CRITIQUE OF BROOKHAVEN NATIONAL LABORATORY,
REVIEW OF METHODS AND CRITERIA FOR DYNAMIC
COMBINATIONS IN PIPING SYSTEMS

R. P. Kennedy - Engineering Decision Analysis Company, Inc.
N. M. Newmark - Consulting Engineering Services

This Document was prepared for the Mark II Owners Group
pursuant to the contract with the General Electric Company

FIGURE 5 . ELASTIC RESPONSE TO UNSCALED SRV, 16 Hz MODEL, 2 PERCENT DAMPING

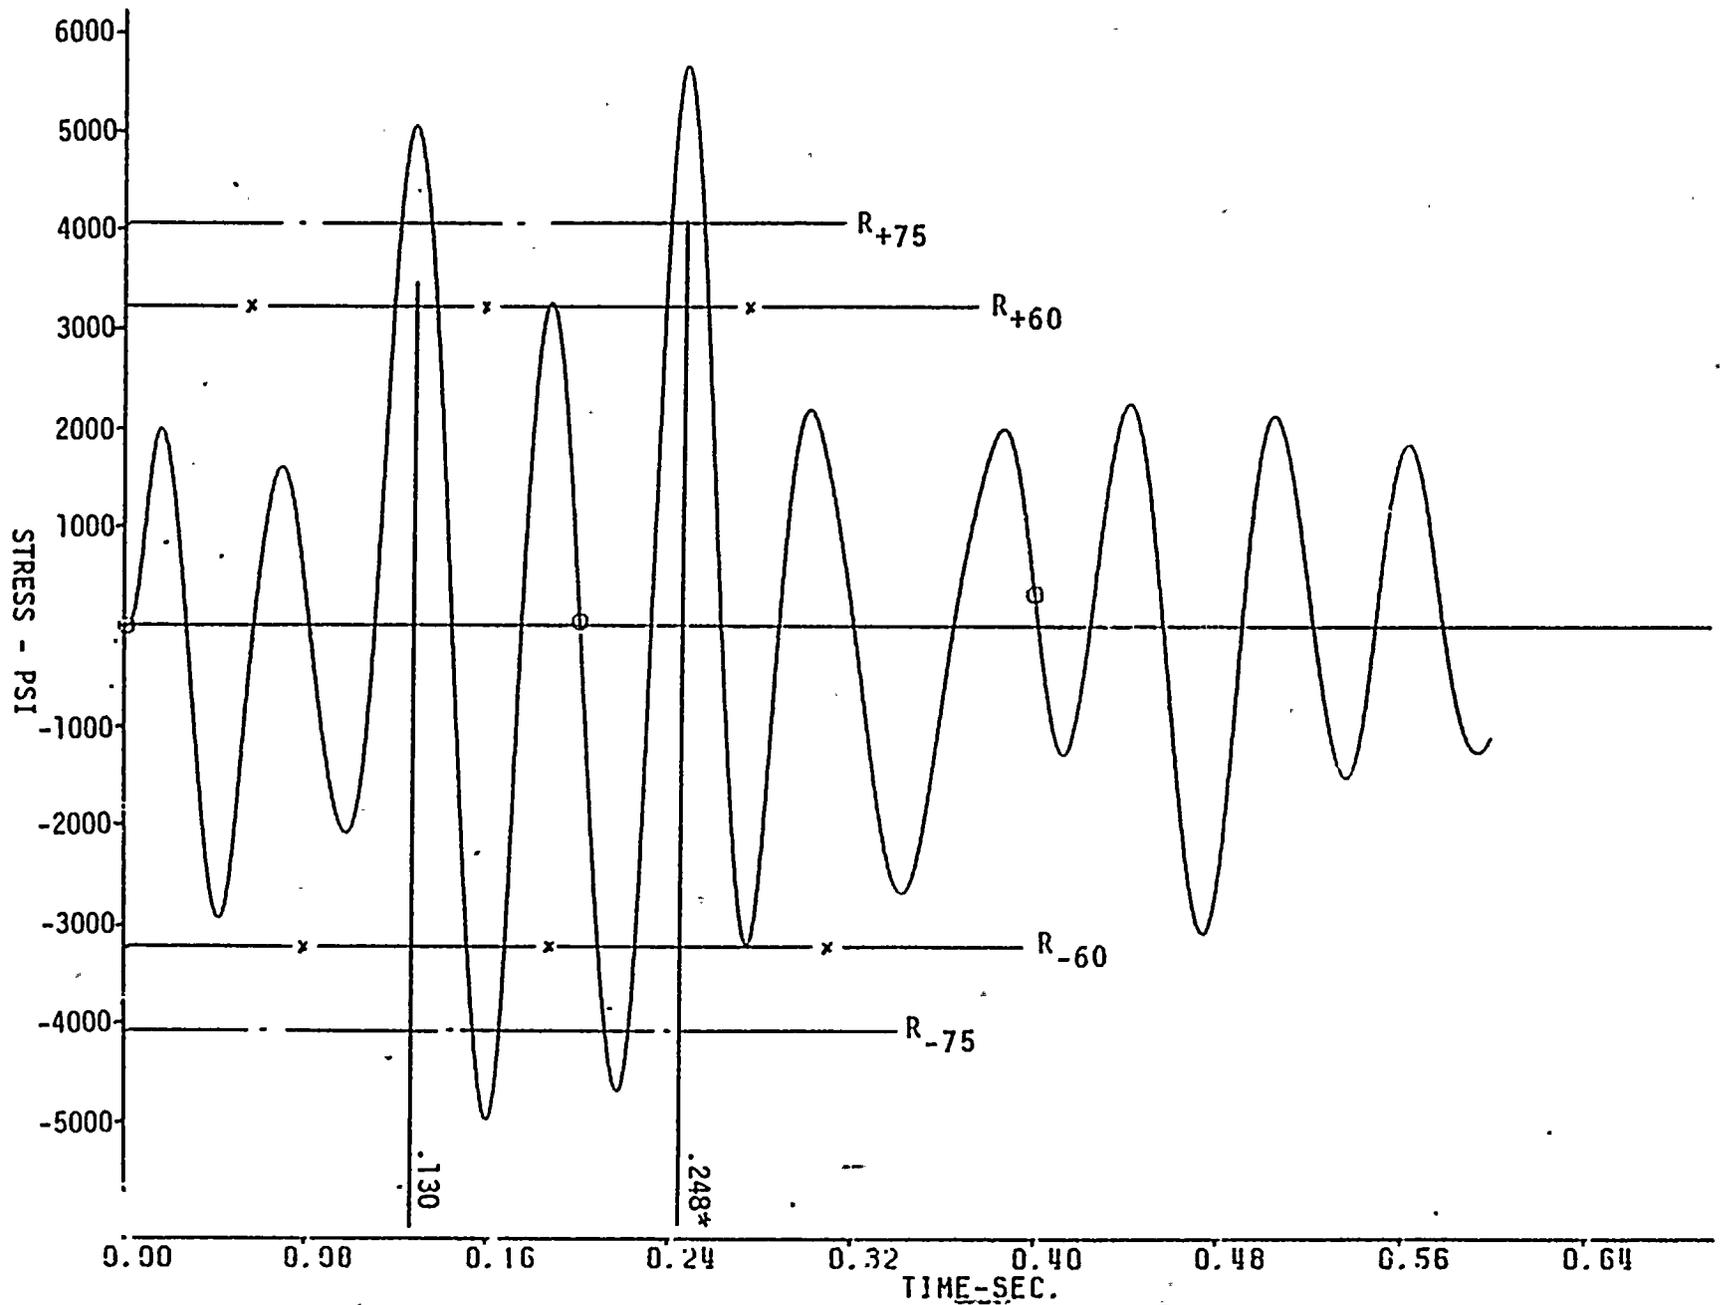
These points are illustrated using the earthquake and SRV load and response time histories shown in Figures 1 through 5. Table 1 presents the number of excursions exceeding 60 and 75 percent of the maximum value for both the loading and response time histories presented in these figures. It can be observed that:

1. Since the SRV loading has less near peak excursions than the earthquake loading, the SRV responses also have less near peak response excursions than the earthquake responses.
2. The number of near peak response excursions exceed the number of near peak load excursions in all cases.

FIGURE 7. COMPARISON OF CASE 1 CDF CURVES AND NEP OF SRSS COMBINATION RESULTED FROM DIFFERENT APPROACHES

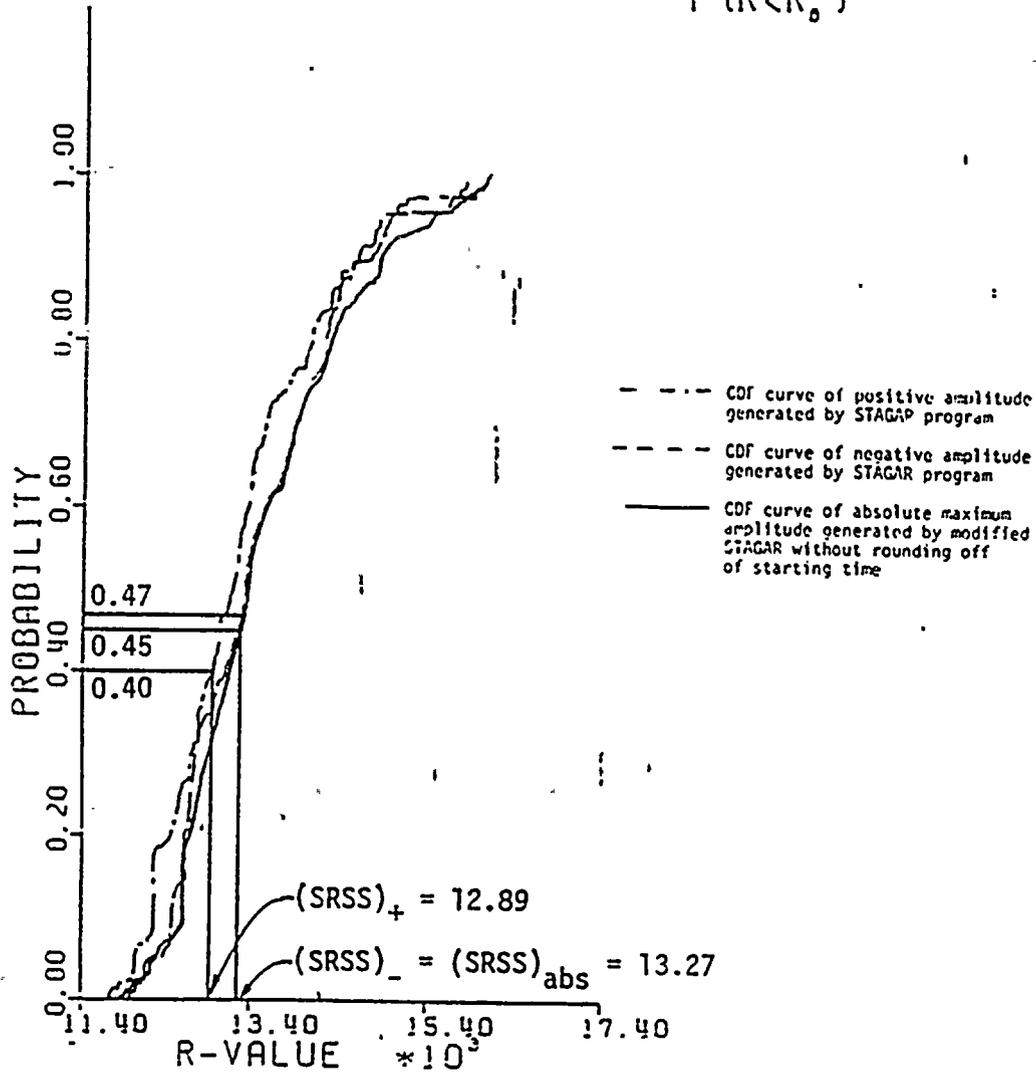
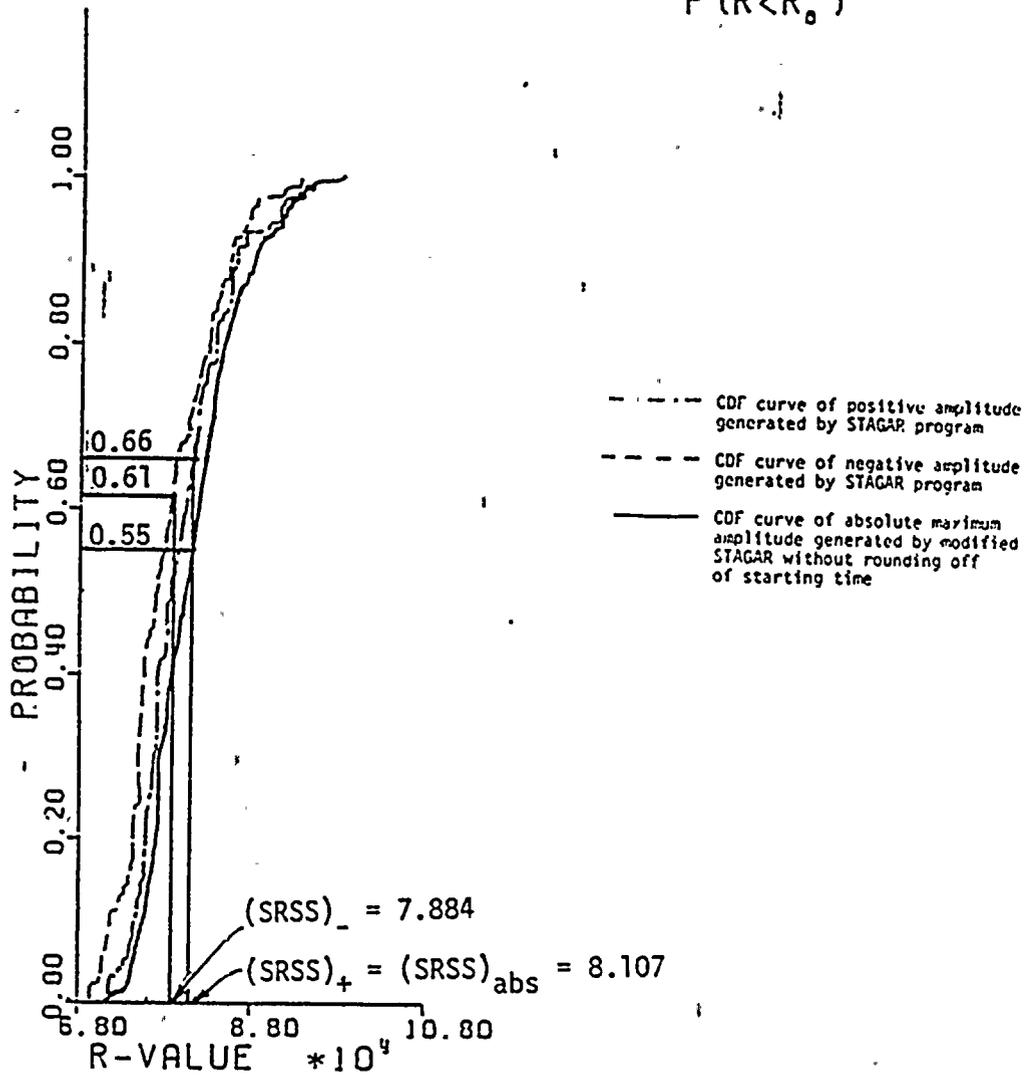
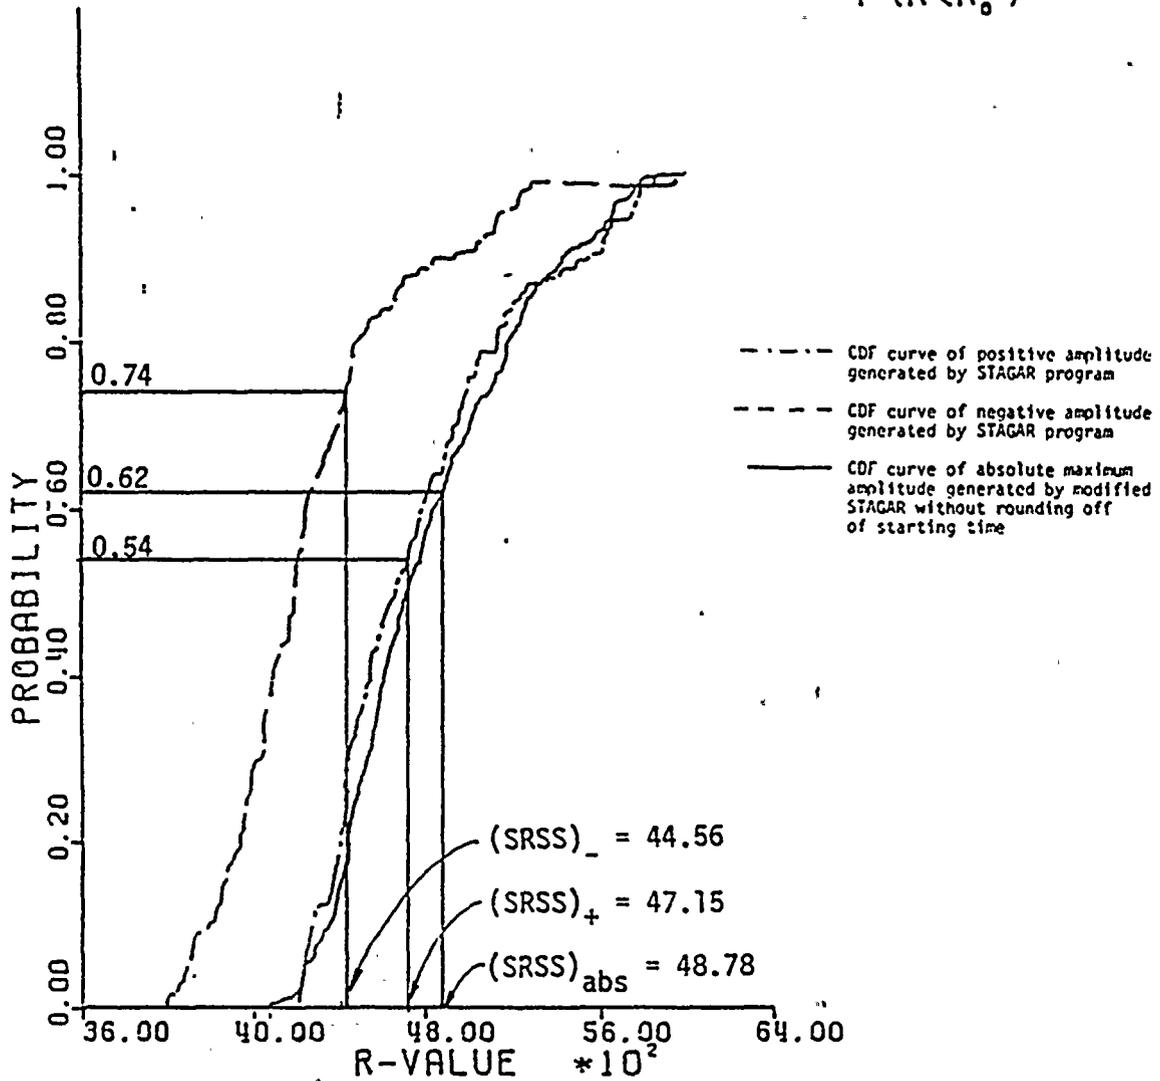
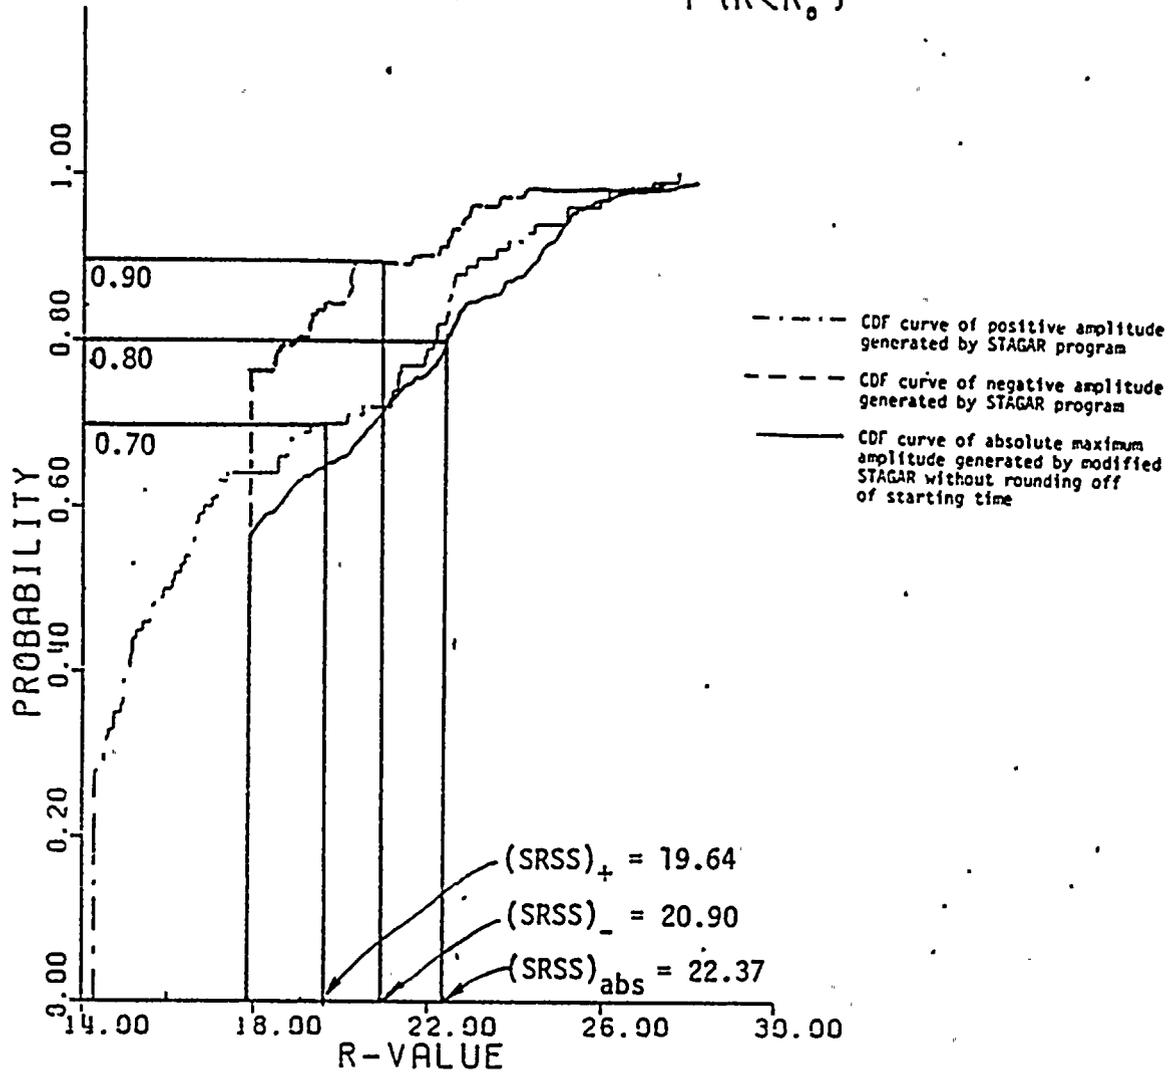
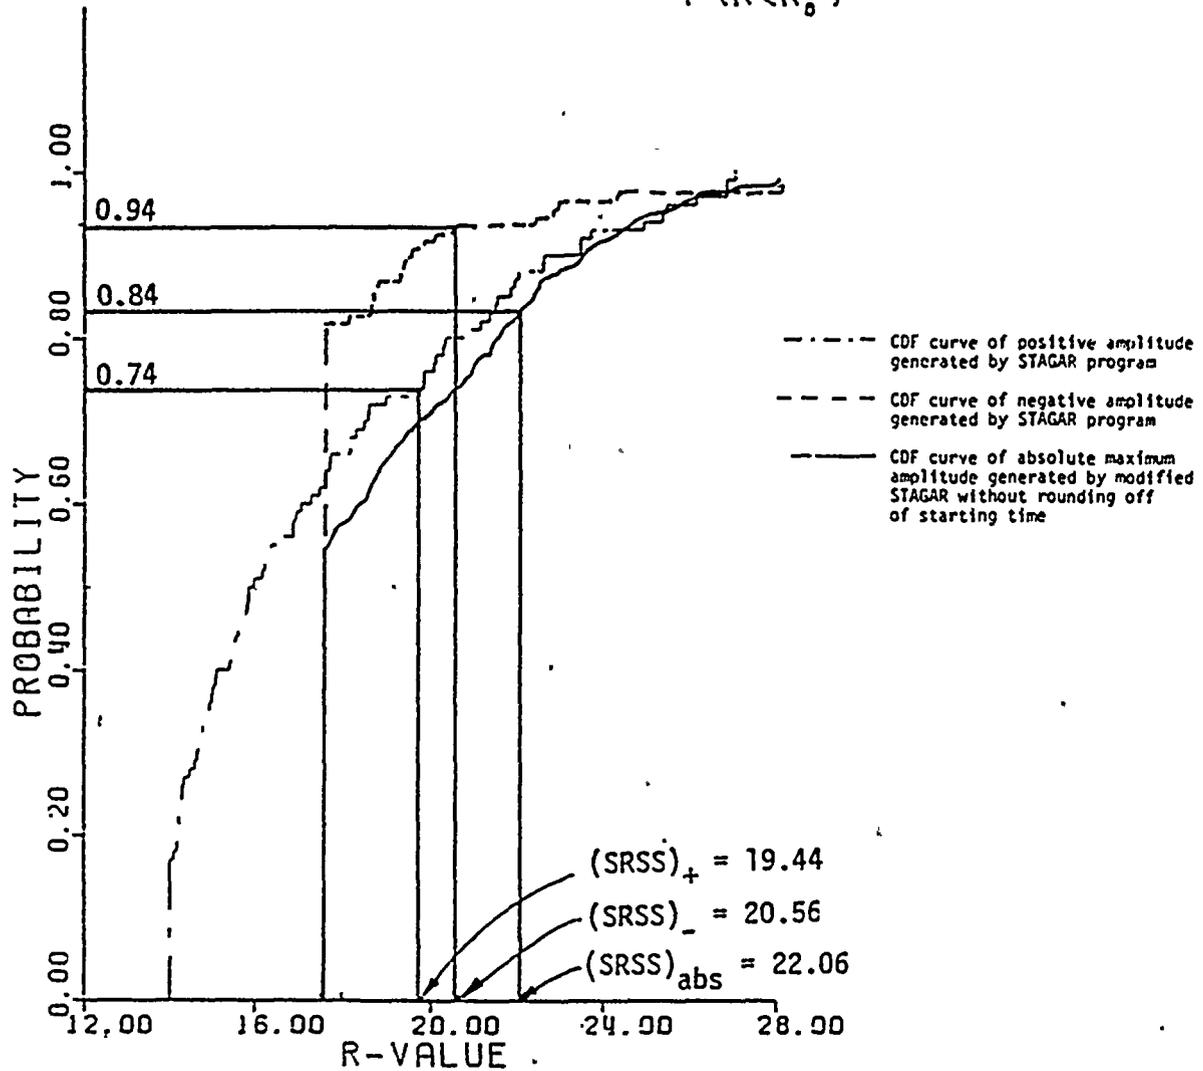
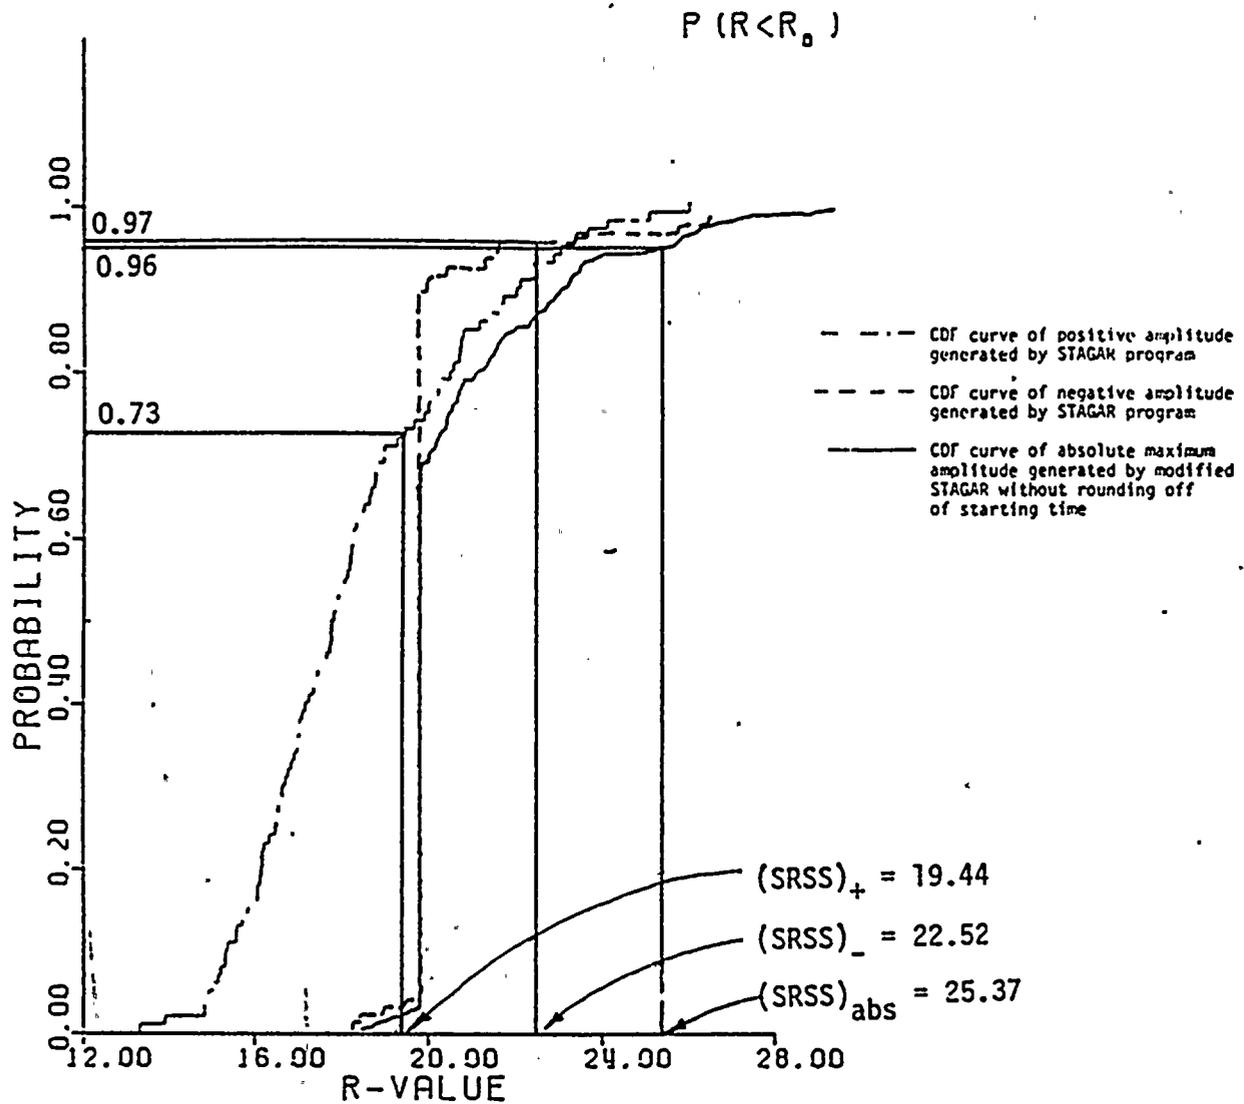
The differences in results for these two methods were studied using the 6 Mark II response combination cases studied in Reference 2. Positive, Negative, and Absolute CDF curves and SRSS values are shown for each of these 6 cases in Figures 7 through 12. Table 3 present the NEP for SRSS combined response and 1.2 SRSS combined response from the two signed CDF curves versus from the single absolute CDF curves.

The Brookhaven report (Reference 4) states that the BNL approach is simpler and less ambiguous and always results in a more conservative NEP for the SRSS combined response. This is not true. As seen in Table 3, the GE and ASME code approach leads to lower NEP for the SRSS combined response in 5 of the 6 cases studied (Cases 1, 3, 4, 5, 6). Only for Case 2 is the BNL method more conservative.

All that can be said is that the BNL method leads to more conservative (lower) NEP for SRSS combined response than that from the higher of the two signed CDF values using the ASME and GE approach. Generally, the NEP for SRSS combined response obtained from the absolute CDF curve lies between the values obtained from the two signed CDF curves and thus is generally less conservative than that from the lower of the two signed CDF curve values.

We tend to agree that the BNL approach is simpler and less ambiguous but it is not more conservative. We see no major reason to prefer one approach over the other and believe that the results presented in Reference 5 which showed that all of the Mark II cases studied pass Criterion 2 remain valid.
